SOUTH CAROLINA ELECTRIC & GAS COMPANY

Subject: Virgil C. Summer Nuclear Station  
Docket No. 50/395  
IEB 79-02

Question: Item 3

Figure 17-4"x4"x1/4" Angle

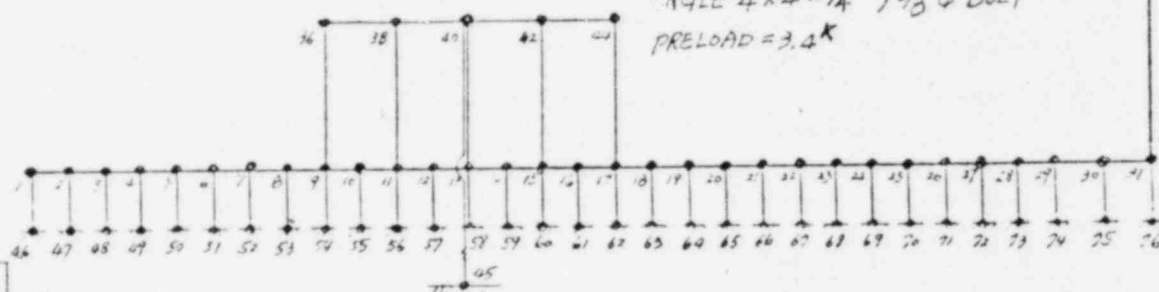
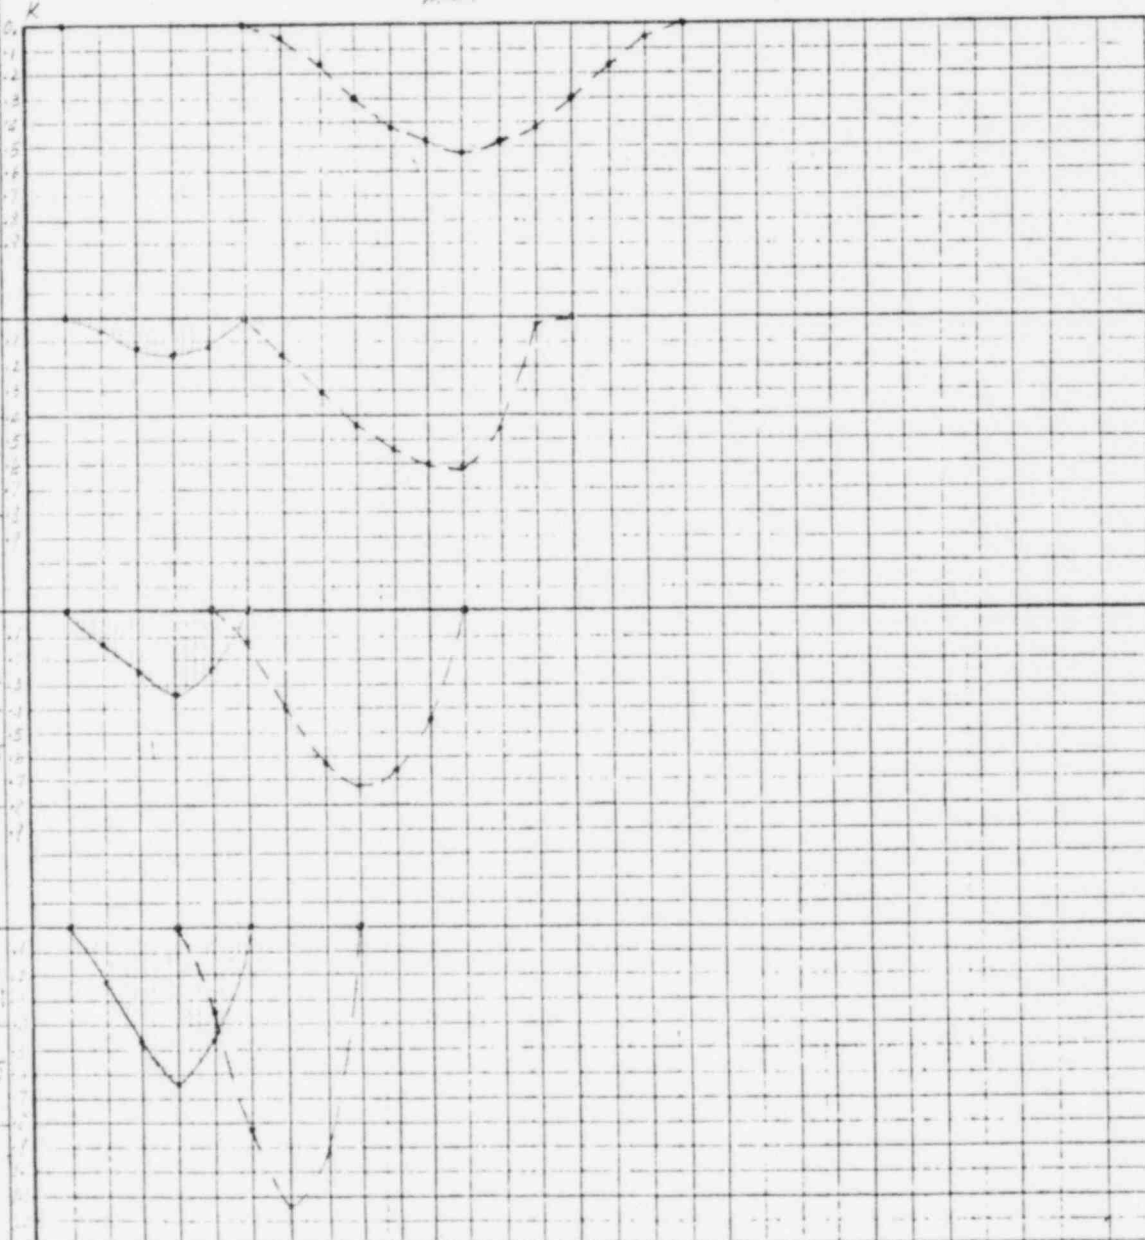
The short direction prying factor shown in the submittal of January 7, 1980 does not include the effect of flexibility of the angle. Show by analysis and by a numerical example that this effect is indeed negligible, or conversely, show how it is taken into account in the design of these angles.

The results of the ANSYS analysis for the case of non-preloaded anchors are plotted in Figures 17 through 19 for angle thicknesses of 1/4", 3/8", and 1/2" respectively. The results show the resultant bolt force and a plot of the pressure at the interface of the angle with the concrete. The interesting observation is that as the angle becomes thicker, the resultant compressive concrete force moves toward the

For the 1/4" thick angle, the compressive force is located at approximately 1.06 inches from the bolt or .71 times the bolt edge distance. This is smaller than the .875 factor used in the prying factor formula. With this smaller moment arm, it would be expected that the prying factor equal to the bolt force (F) divided by the applied load (P) would be higher than the theoretical value of 2.9 predicted by the prying factor equation. Actually taking the ANSYS produced bolt tension and dividing it by the applied load, the factor is 2.82 based upon an applied load of .52 kips producing a bolt force of 1.46 kips. The factor is lower than the theoretical because for this angle thickness, 18% of the applied moment at the bolt line is resisted by the bending stiffness of the bolt. This leaves only 82% of the applied moment to be resisted by the concrete compressive force times 1.06 inches. The bending stiffness of the bolt and its influence on resisting the applied bending moment are ignored by the prying factor equation.

This model was again loaded in increments by a vertical load on the centerline of the outstanding angle leg. The results of this analysis for the concrete pressures are also plotted on Figures 17 through 19 for the 4" x 4" angle. For the preloaded bolt case, it is apparent that the behavior is significantly different from the

What can be examined, however, is the bolt force at the applied load level equal to .52 kips. This is the maximum load, for all thicknesses of 4" x 4" angles, which is permitted to be applied to this angle and bolt system, based on the prying factor formula. For this applied load level, the bolt forces are 3.499 kips, 3.468 kips, and 3.442 kips respectively for the cases of 1/4", 3/8", and 1/2" thick angles. The highest of these is only 3% in excess of the preload value of 3.4 kips. This small increase above the preload value is insignificant leading to the conclusion that for the load level predicted by the prying factor formula, the bolt is essentially still only experiencing its initial preload.
